Secretary's Order No. 2013-A-0011

Re: Application of Delaware City Refining Company, LLC, for Air Pollution Control Permit to Restart the Ether Plant Cooling Tower Equipment (Unit 43) at the Delaware City Refinery, Delaware City, New Castle County

SUBJECT: **Response Document Developed by the Division of Air Quality (DAQ) for the Public Hearing Held on December 19, 2012 for The Delaware City Refining Company (DCRC) to Restart the Ether Plant Cooling Tower at the Delaware City Refinery.**

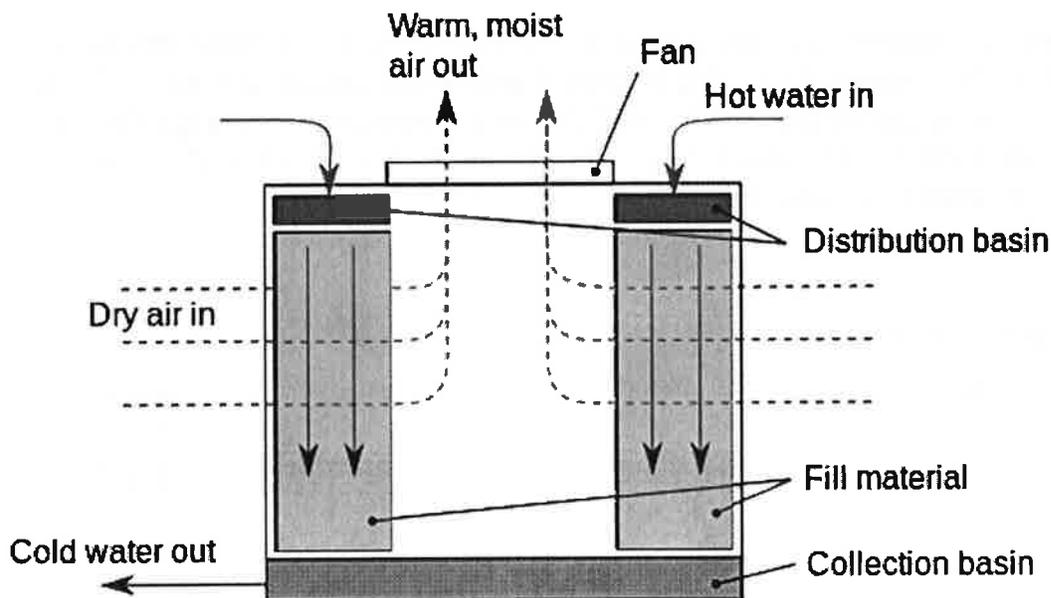
Sierra Club Comment # 4: Page 3 of the application describes that "the cooling tower will operate as permitted in the past." However, a description of this is not provided in the application document. The permit application therefore provides an incomplete picture of the operation of the cooling tower.

DAQ Response: The application does in fact provide a detailed pdf copy of the piping and instrumentation diagram (P&ID) showing the affected cooling tower (43-UM-901A/B/C) and the associated flow domains. The evaporation and drift losses are shown coming off the top of the tower. A more simplistic version of a cooling tower depicting its operation is appended below.
